CS Memorandum No. 1331

Subject: Configuration Management Board Meeting No. 108

CMB Meeting Minutes #108

SUBJECT: Configuration Management Board Meeting # 108 – Rev. No. 0

Removed 12" Steel Pipe from
CTL Sta. 80+26 to 80+37

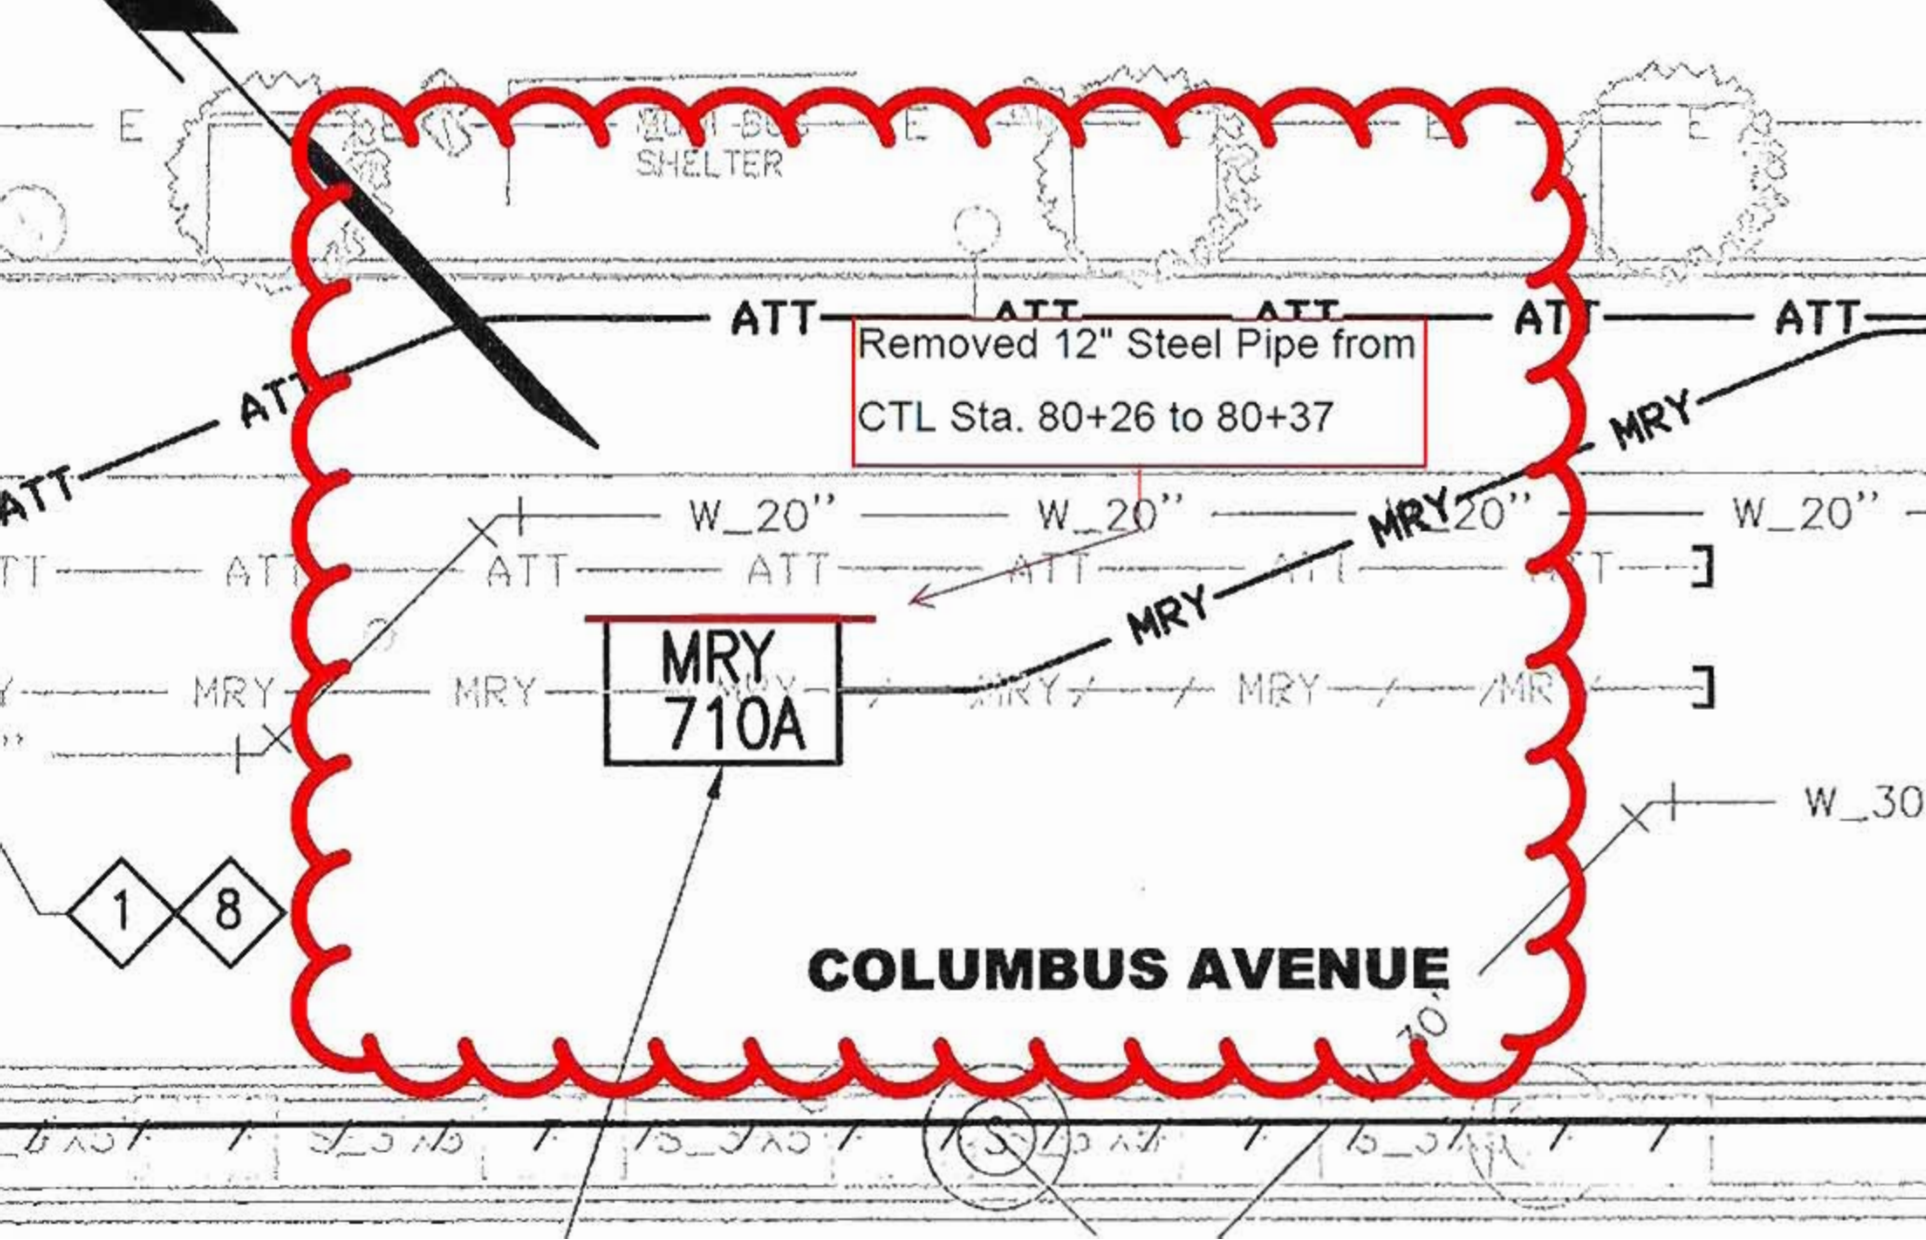
1	1252 – S. Wilson presented Evaluation of Merit of, COR 031 – Retrieval Shaft – Unmarked 12" Steel Pipe – Contractor discovered and removed a 12" steel pipe running continuously under Columbus Ave. between Powell and Union Streets. Removal was necessary to complete the Joint trench work. CMB agreed with merit for differing site condition work associated with removal of pipe	
2-	1252 – S. Wilson presented Evaluation of Merit of, COR 061 – Eight inch Abandon Water Main – Contractor encountered an 8" main in the middle of the SW panel P-17 at the TBM Launch Box approximately 6" below the guidewall. Pipe was not shown on drawings. CMB agreed with merit for differing site condition work associated with removal of pipe.

Contractor Rationale for COR: The steel pipe constitutes a differing site condition, as it was not shown on the drawings at the time of bid.

Justification: RE has evaluated the conditions outlined in Article 3.04 and found that: conditions differ materially and conditions have caused the scope of work to increase.

Approx. Location of
SW Panel P-17

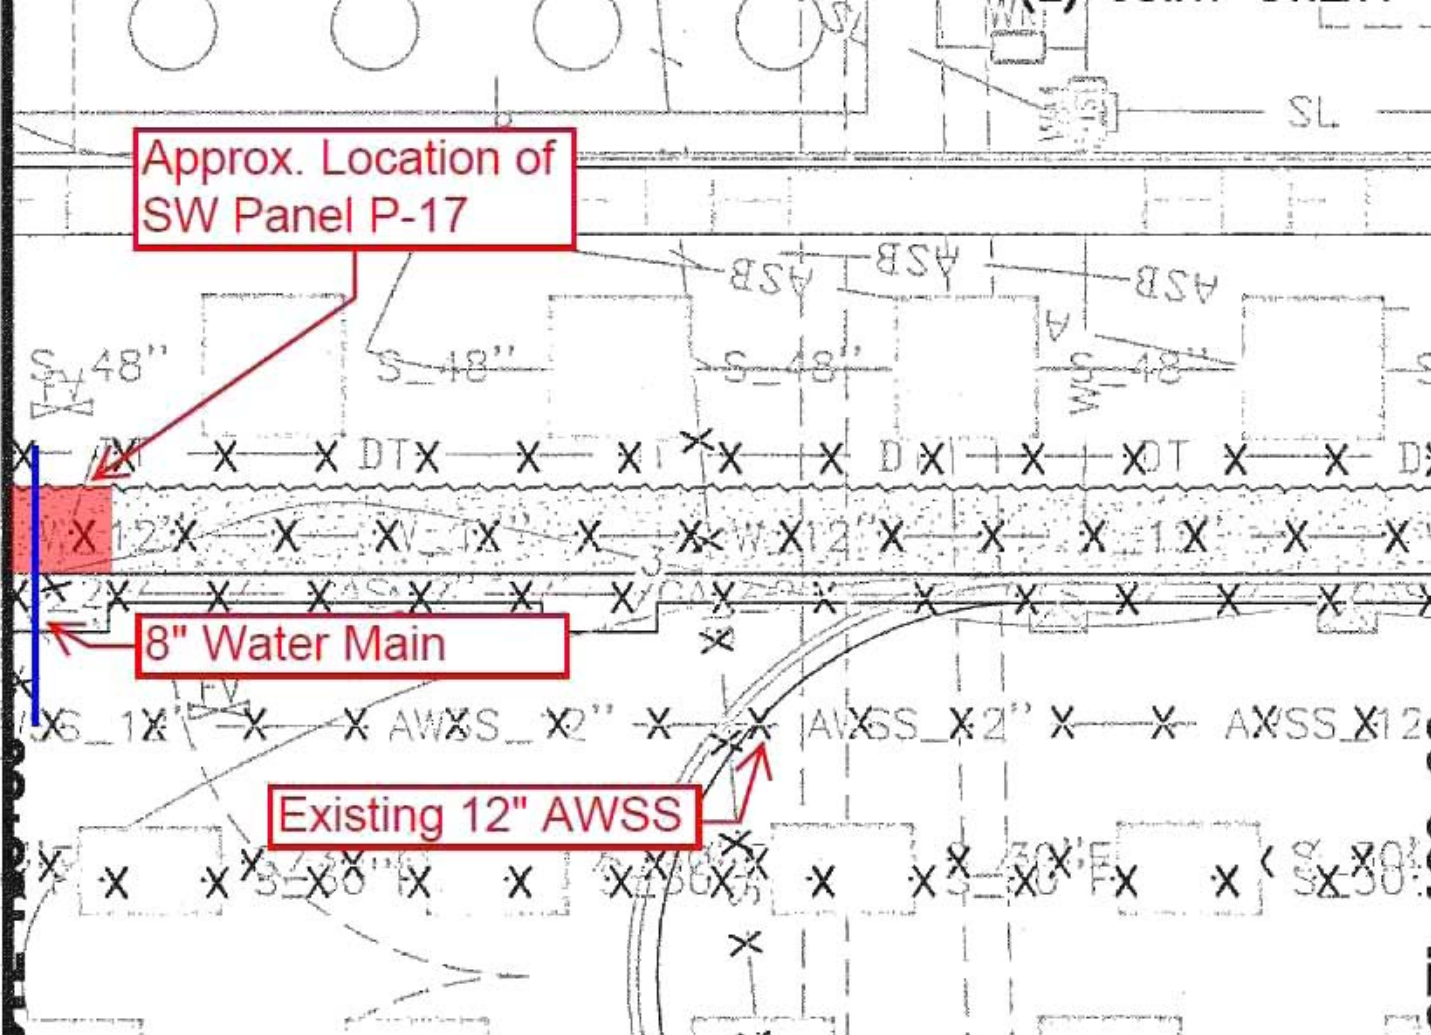
Contractor Rationale for COR: The contract does not indicate the presence of the water main within the footprint of SW panel P-17. The water main has prevented slurry diaphragm wall construction from occurring as originally planned.

Justification: RE has evaluated the conditions outlined in Article 3.04 and found that: conditions differ materially and conditions will cause scope of work to increase.

Sta. 164+60, Panel P-9

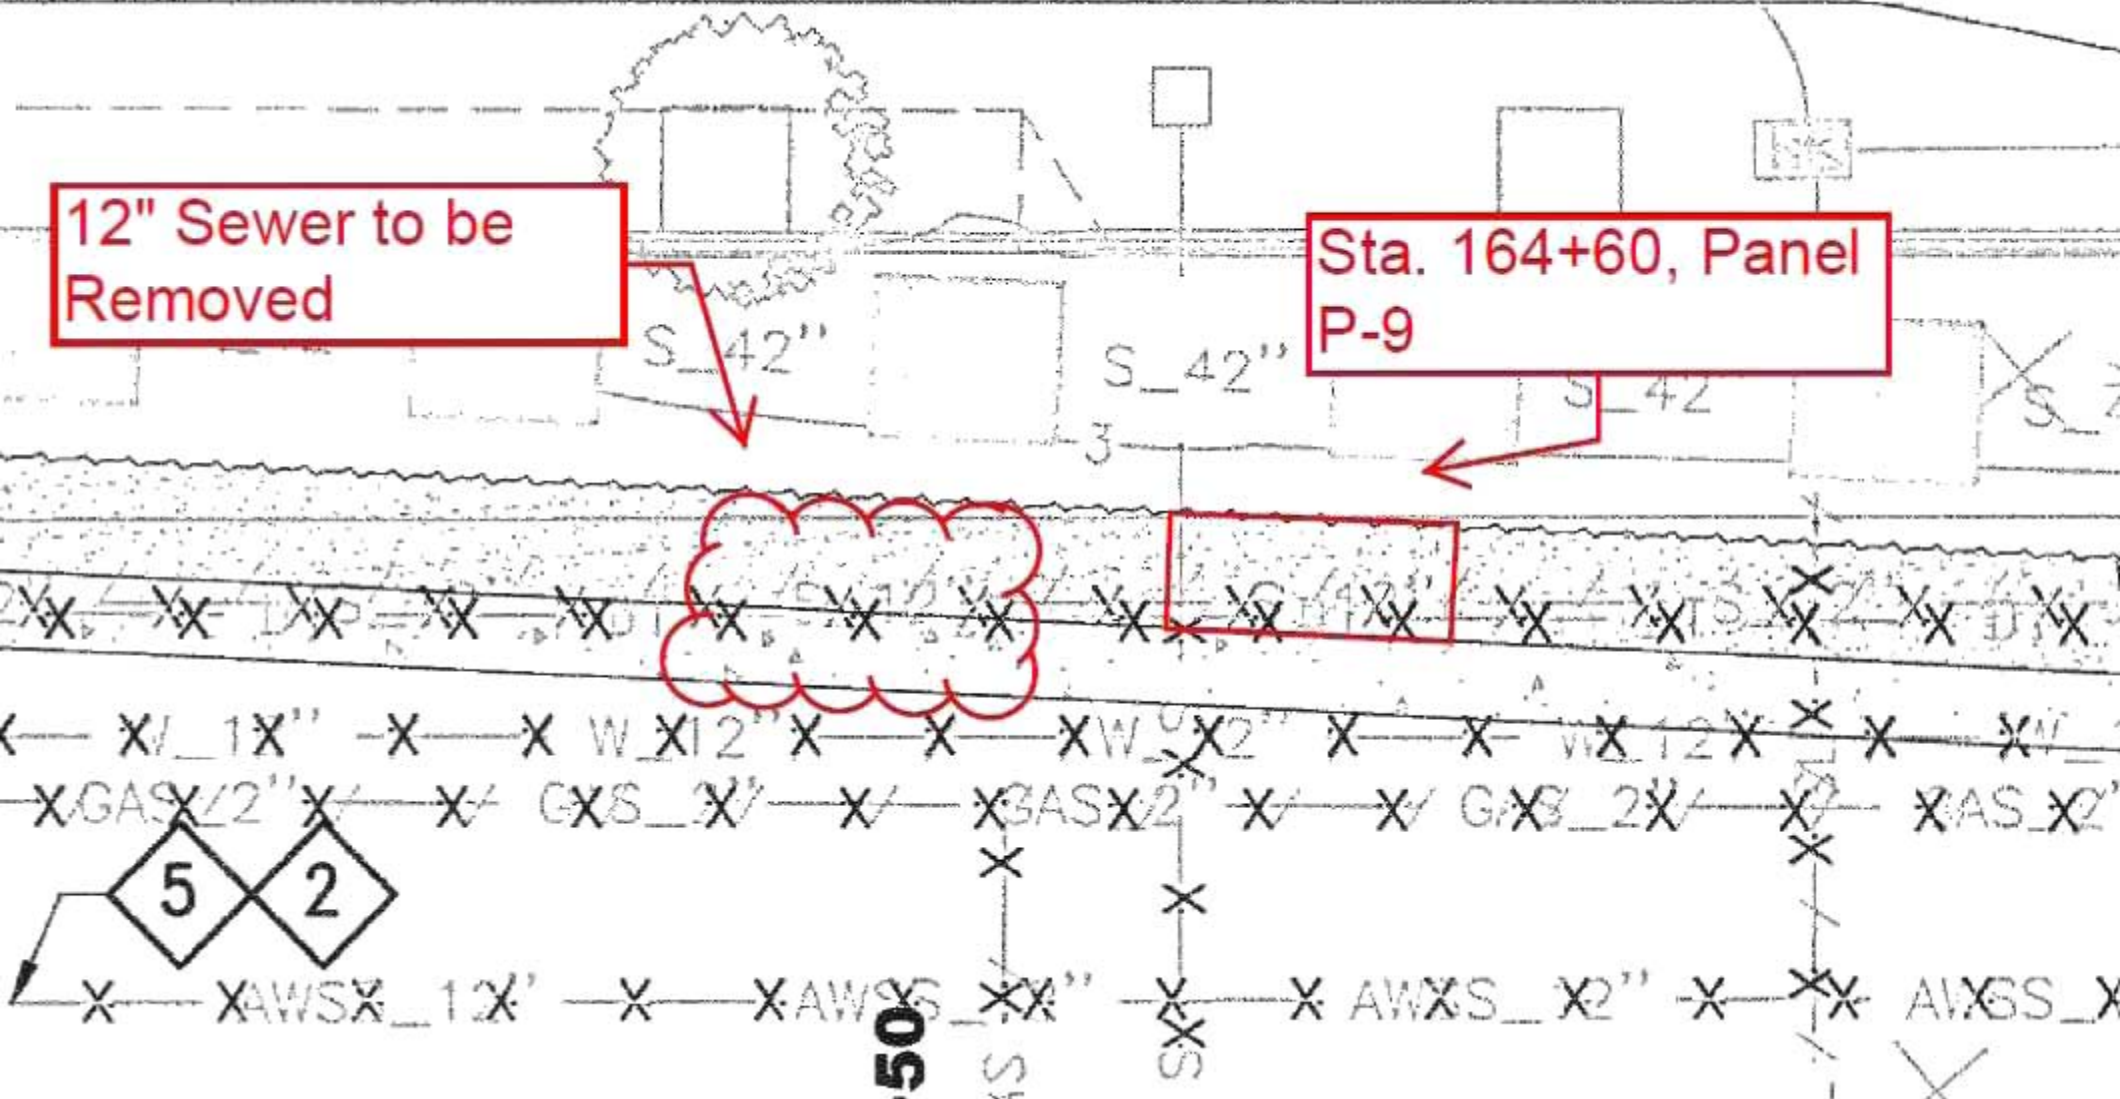
Facts: On November 7th 2012, the Contractor encountered concrete encasement around a 12 inch clay sewer pipe within Slurry Wall (SW) panel P-9 at the TBM Launch Box approximately 8 feet below the top of the SW guidewall. The concrete encasement caused the SW to deviate from the designed excavation limits. To correct the verticality of the panel excavation, the panel was backfilled with lean concrete and re-excavated. The Contractor is claiming the obstruction caused 4 working days delay to the SW work.

Contractor Rationale for COR: The contract does not indicate the presence of the concrete encasement within the footprint of SW panel P-9. The concrete encasement has prevented SW construction from occurring as originally planned.

Justification: RE has evaluated the conditions outlined in Article 3.04 and found that: conditions differ materially and conditions will cause scope of work to increase.

Sta. 164+97, Panel P-12

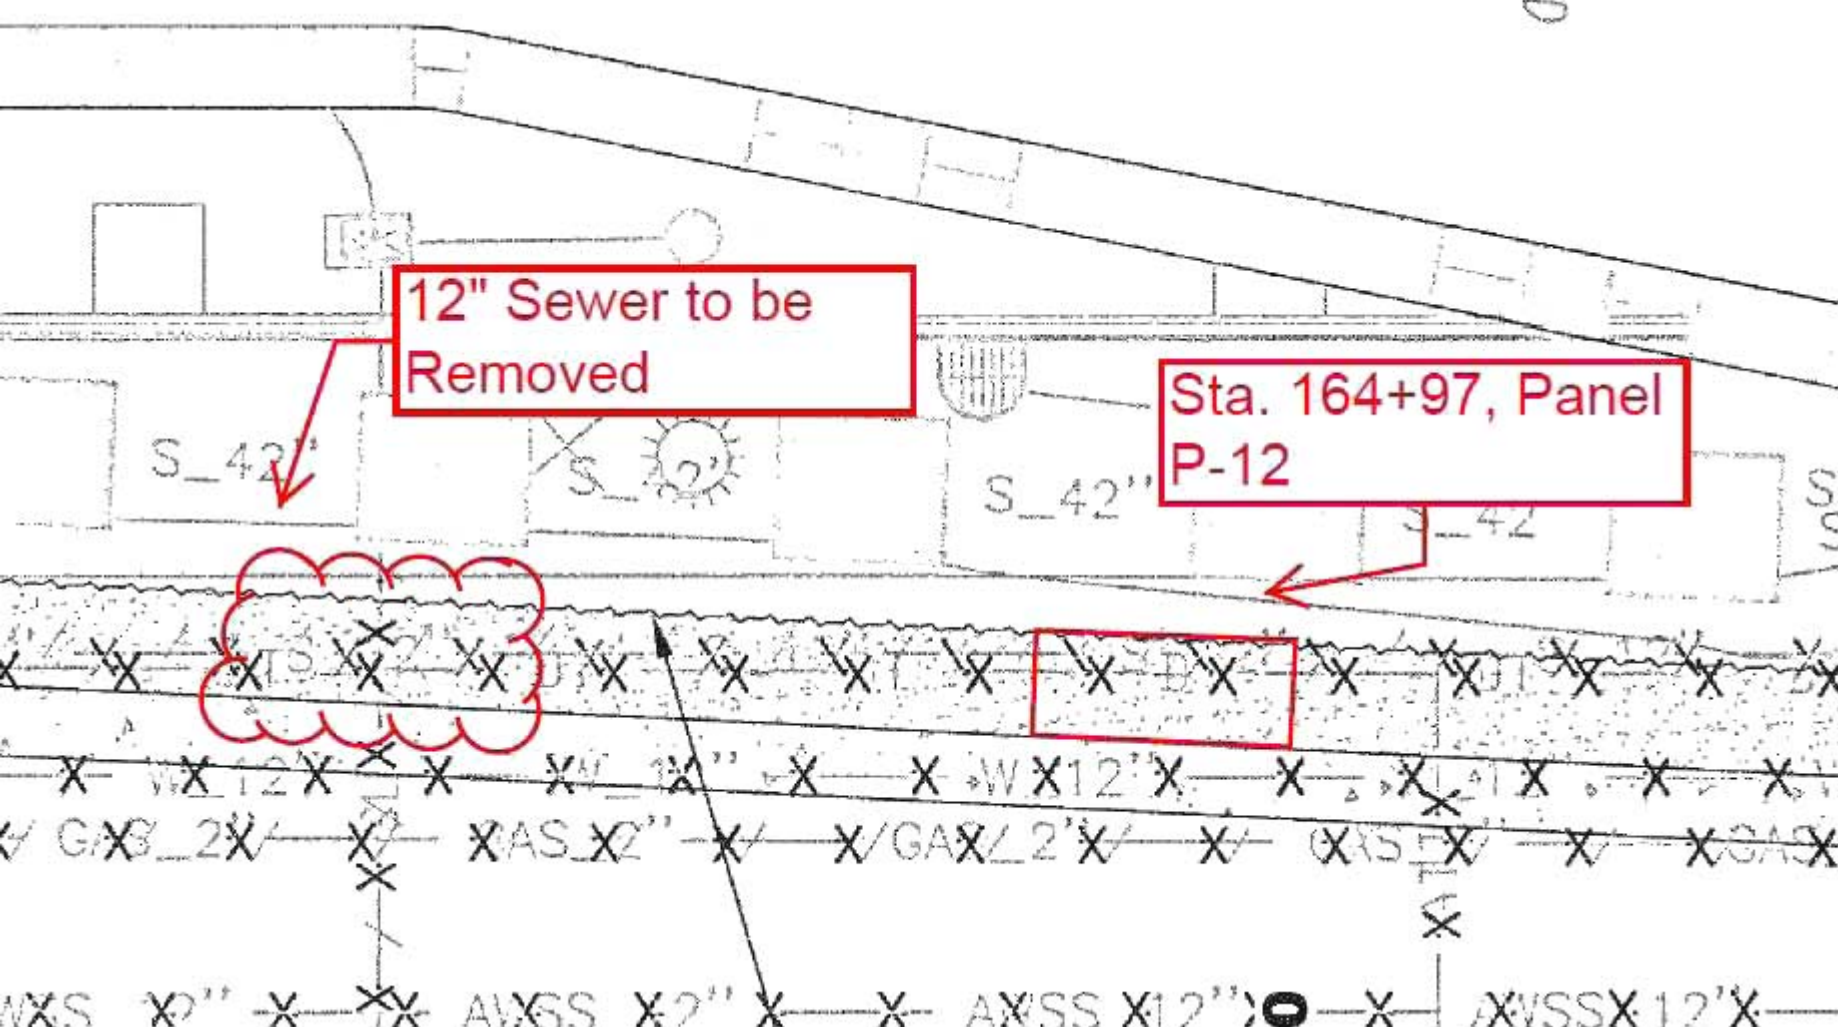
Facts: On November 13th 2012, the Contractor encountered concrete encasement around a 12 inch clay sewer pipe within Slurry Wall (SW) panel P-12 at the TBM Launch Box approximately 7 feet below the top of the SW guidewall. The concrete encasement caused the SW to deviate from the designed excavation limits. To correct the verticality of the panel excavation, the panel was backfilled with lean concrete and re-excavated. The Contractor is claiming the obstruction caused 4 working days delay to the SW work.

Contractor Rationale for COR: The contract does not indicate the presence of the concrete encasement within the footprint of SW panel P-12. The concrete encasement has prevented SW construction from occurring as originally planned.

Justification: RE has evaluated the conditions outlined in Article 3.04 and found that: conditions differ materially and conditions will cause scope of work to increase.
